7ELEVEN AT WALLBROOK (LOT 11)

SITE DEVELOPMENT PLAN

US-401 Business / S. Main Street ~ Wake Forest Township ~ Town of Rolesville ~ Wake County ~ North Carolina

COVER - OVERALL SITE PLAN
7ELEVEN AT WALLBROOK (LOT 11)
Town of Rolesville Project No. SDP 23-
US 401 Business / S. Main Street & Virginia Water Drive
Wake Forest Township, Town of Rolesville, Wake County, North Carolina

C2.0
 Date: May 2023

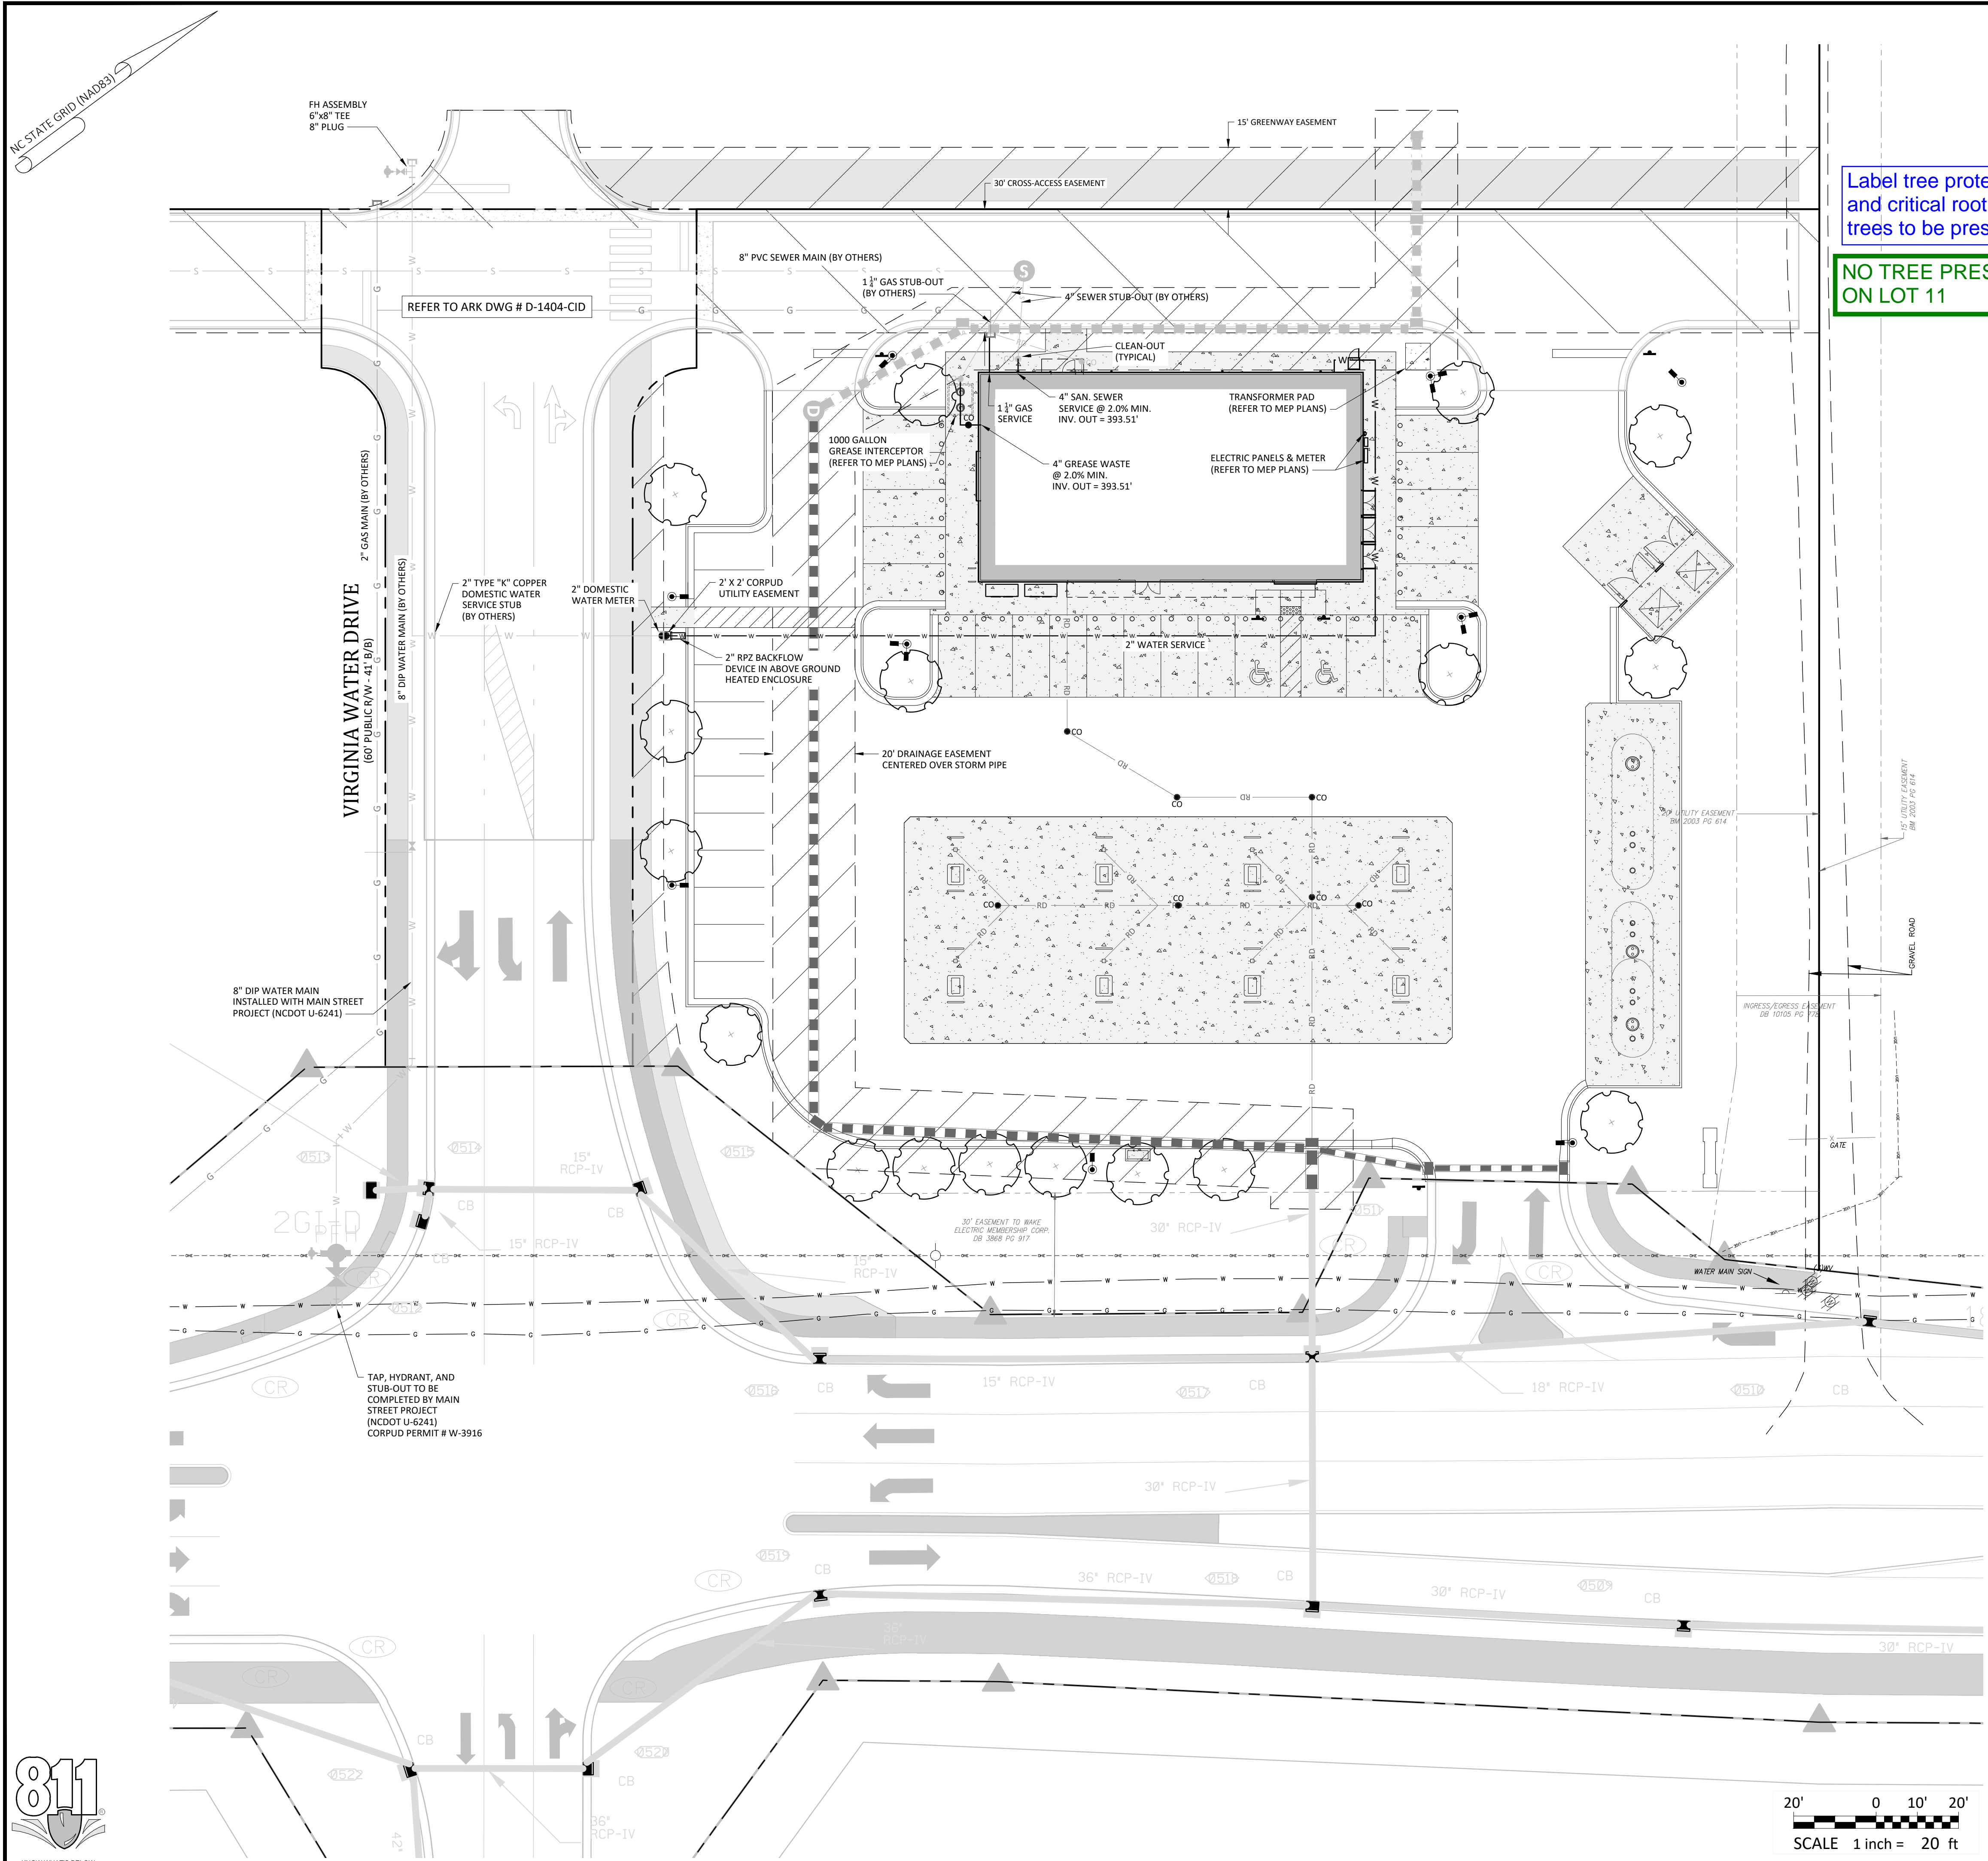
Is this path to be installed as a part of this plan? If not, please reference the case number.

Show and label side setback consistent with other setback lines. Clearly indicate building envelope.

Please provide a lighting plan.

Clarify the plan in which sidewalk installation will occur.

Include all street names. ADDED

Show and label site distance triangles.

Update to provide a key or legend that clearly states what each symbol means as well as provides insight into the different impervious surface materials shown.

TRANSFORMER PAD. NOTED ON SHEET C3.0

SIDE SETBACK OVERLAPS WITH 20' UTILITY EASEMENT. LABEL ADDED

SITE LIMITED TO 85% IMPERVIOUS AREA AS ACCOUNTED FOR IN THE WALLBROOK STORMWATER MASTER PLAN

LEGEND ON SHEET C0.1

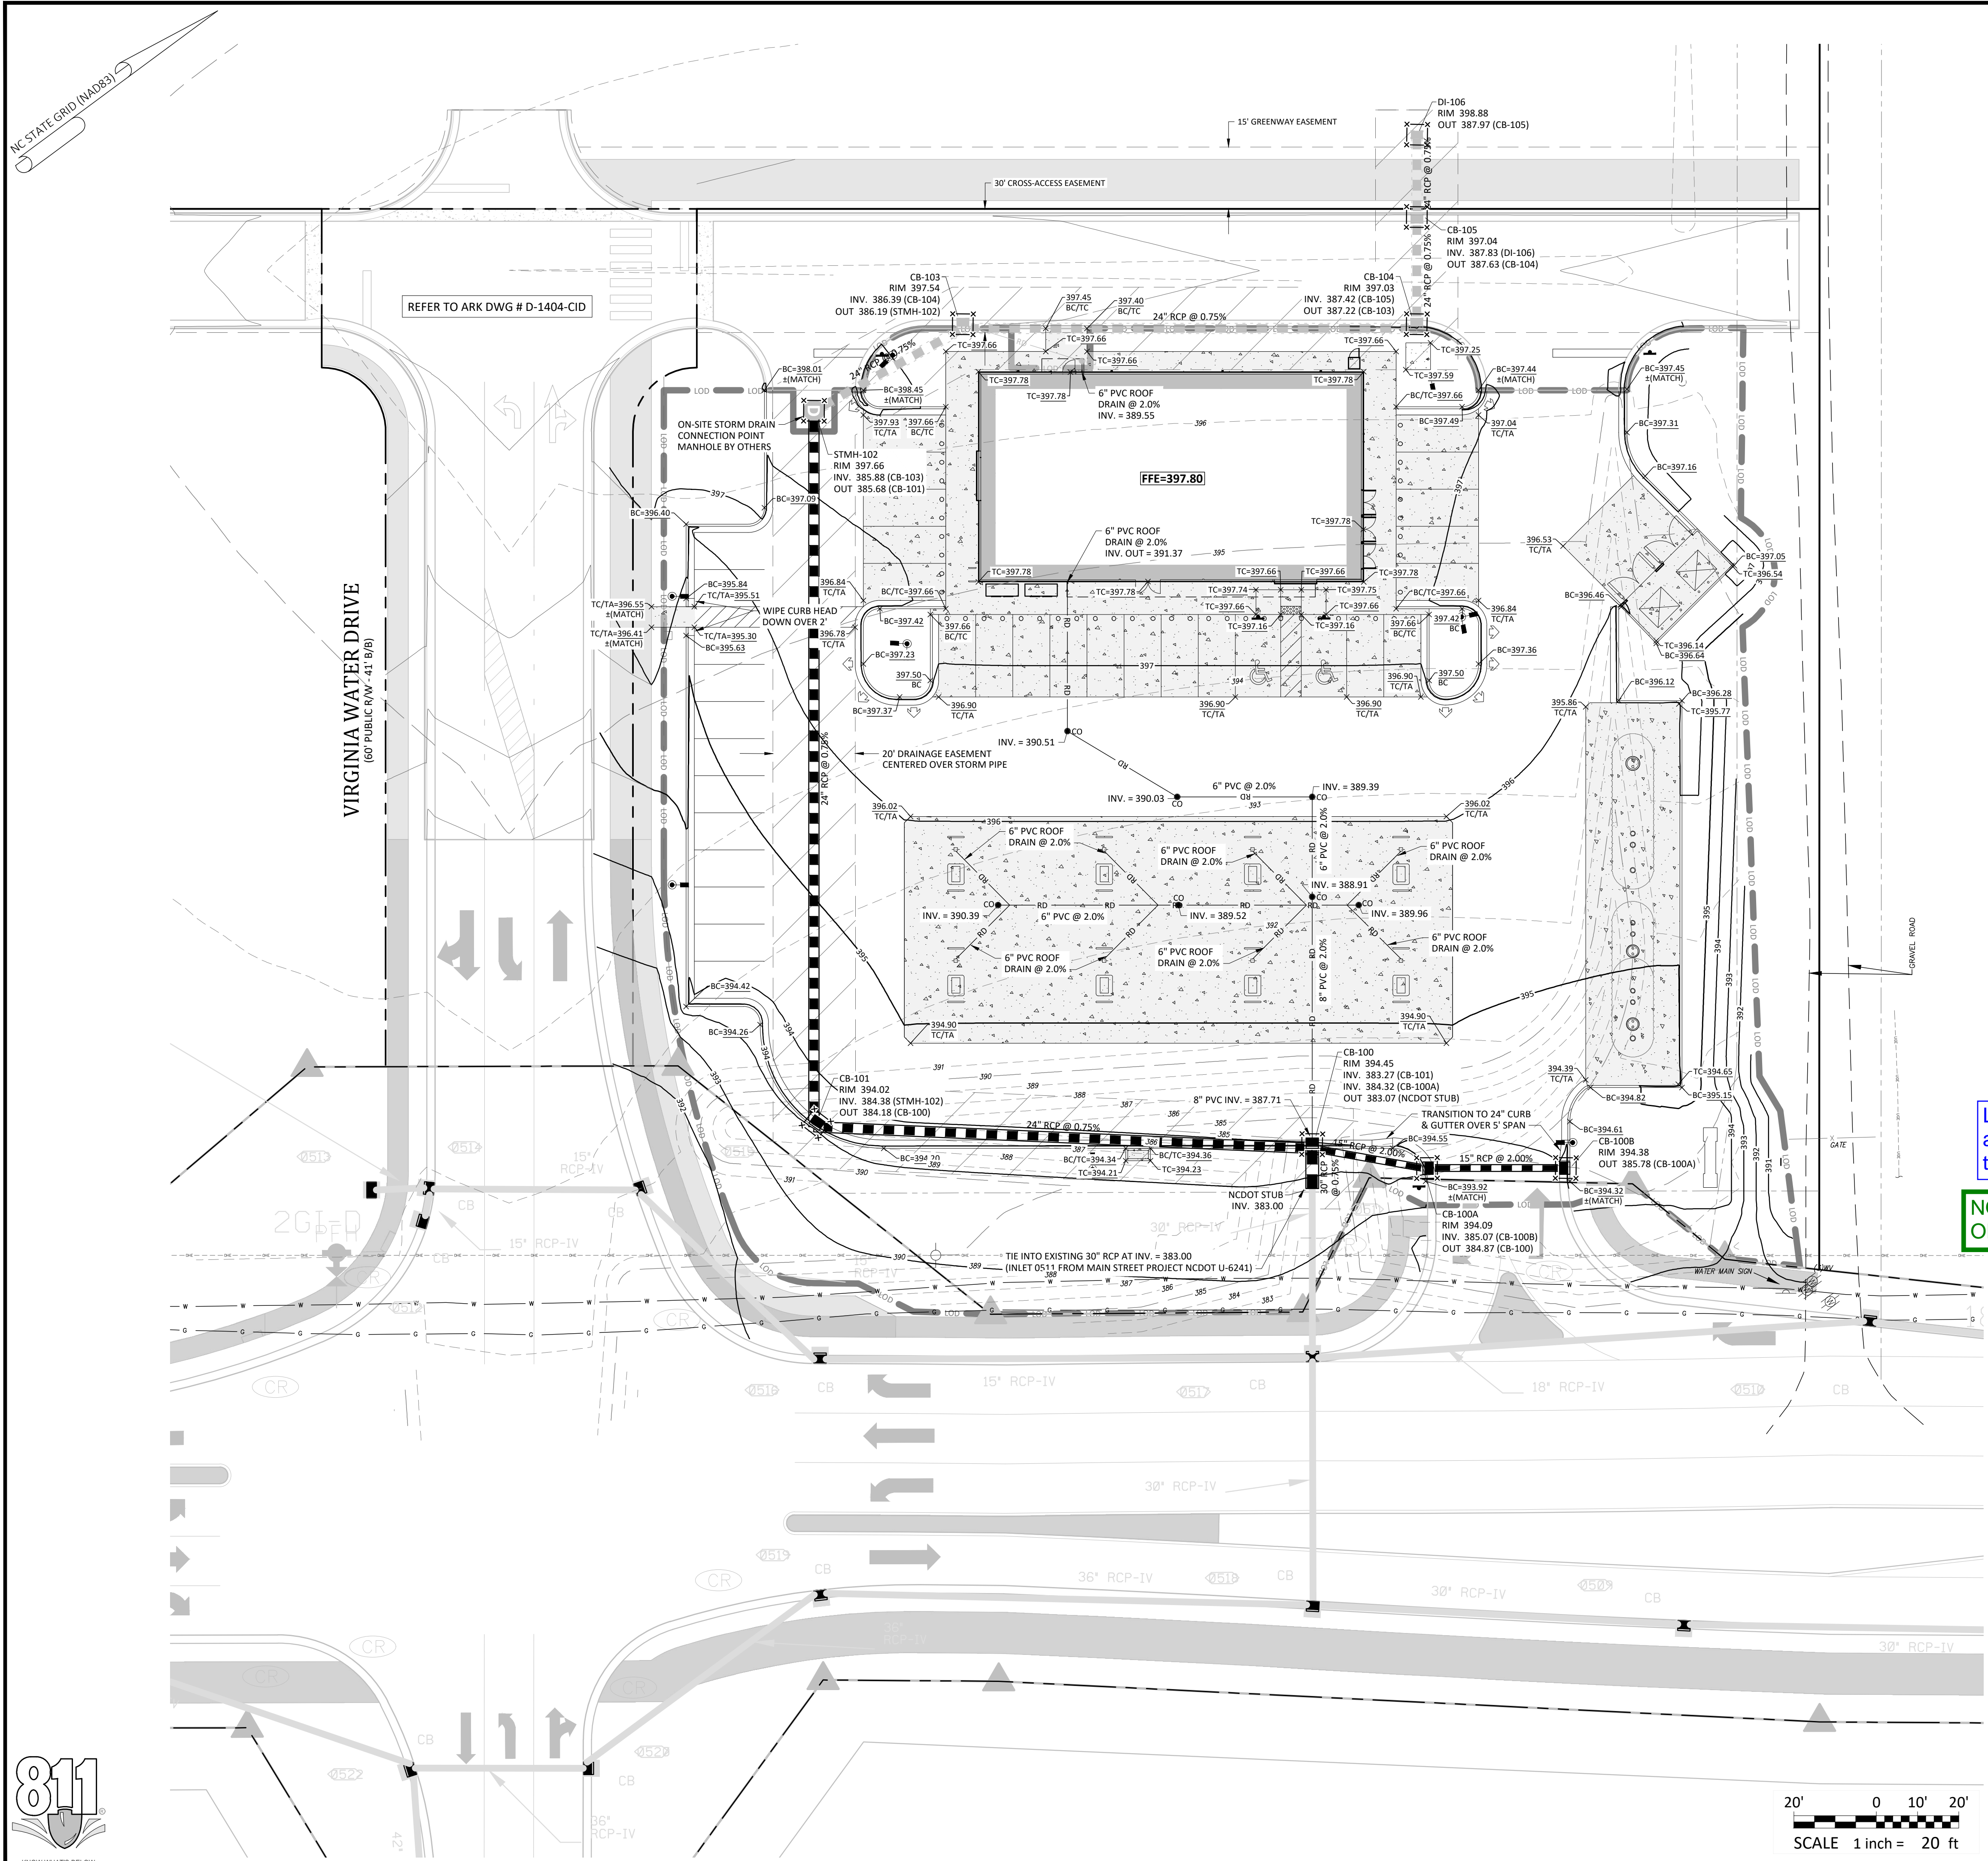
Provide a legend or key of what symbols mean.

LEGEND ON SHEET C0.1

GRADING PLAN
7ELEVEN AT WALLBROOK (LOT 11)
Town of Rolesville Project No. SDP 23-
US 401 Business / S. Main Street & Virginia Water Drive
Wake Forest Township, Town of Rolesville, Wake County, North Carolina

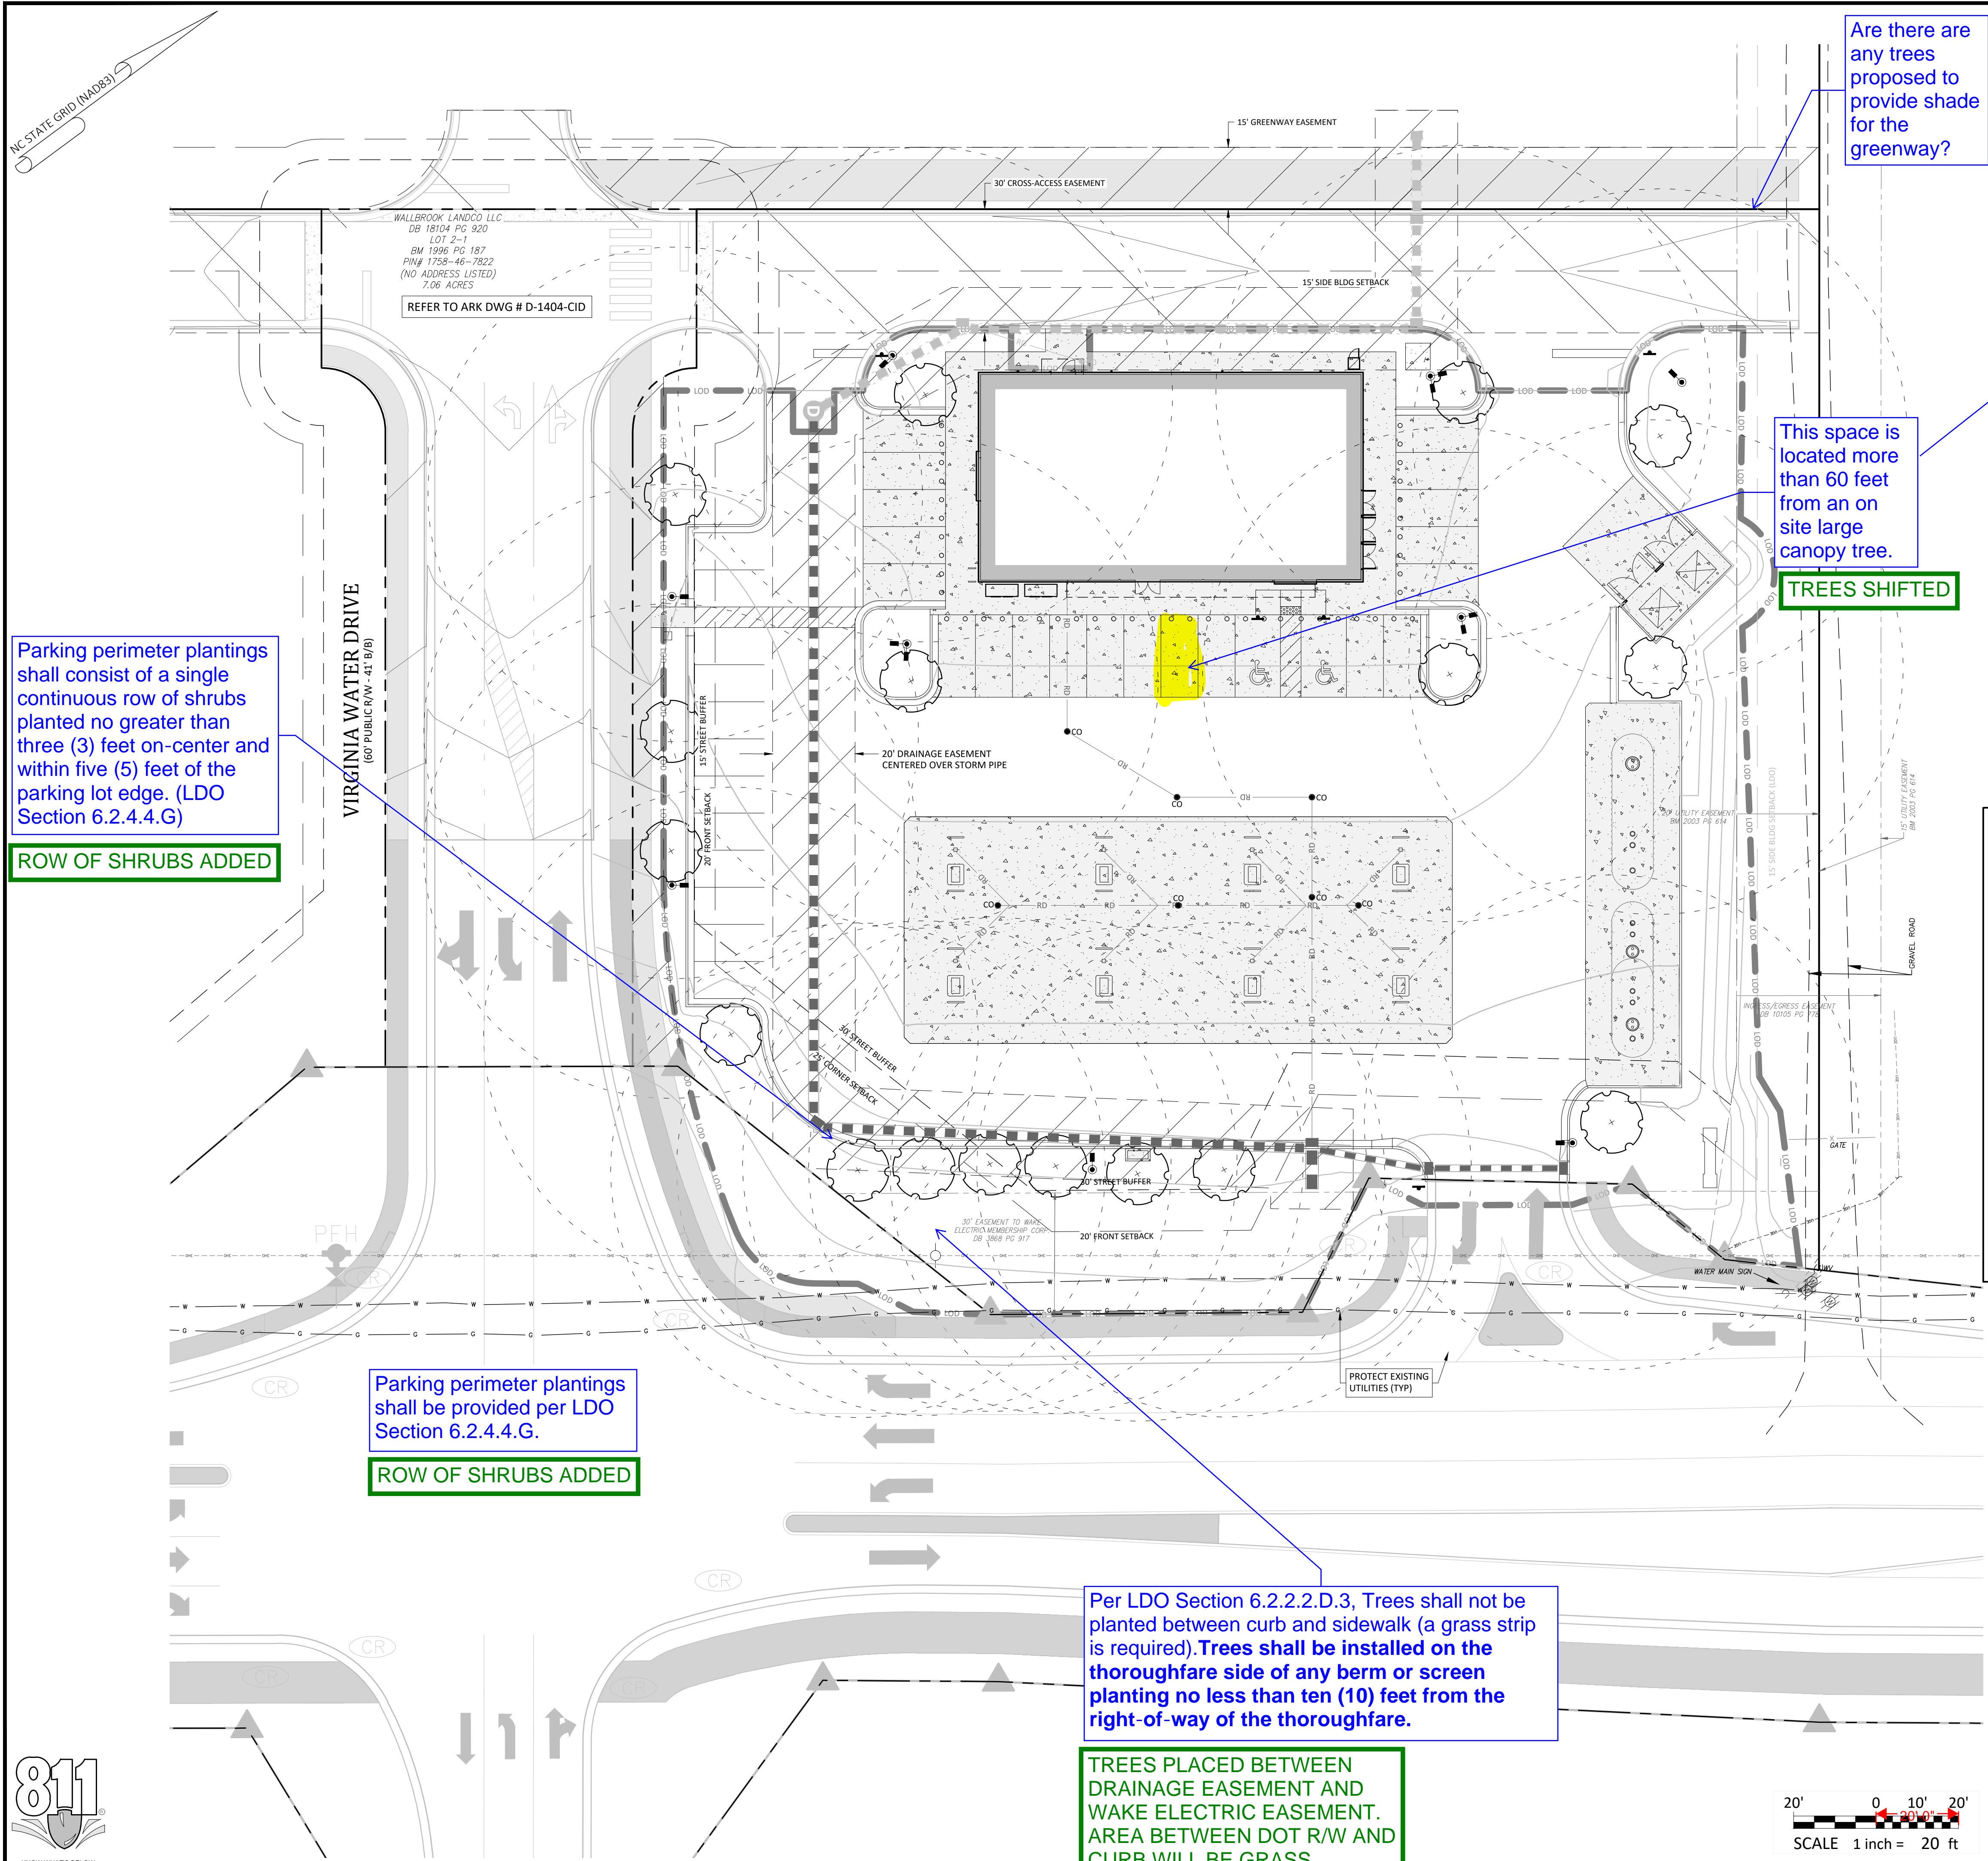
Provide a legend or key of what symbols mean.

LEGEND ON SHEET C0.1
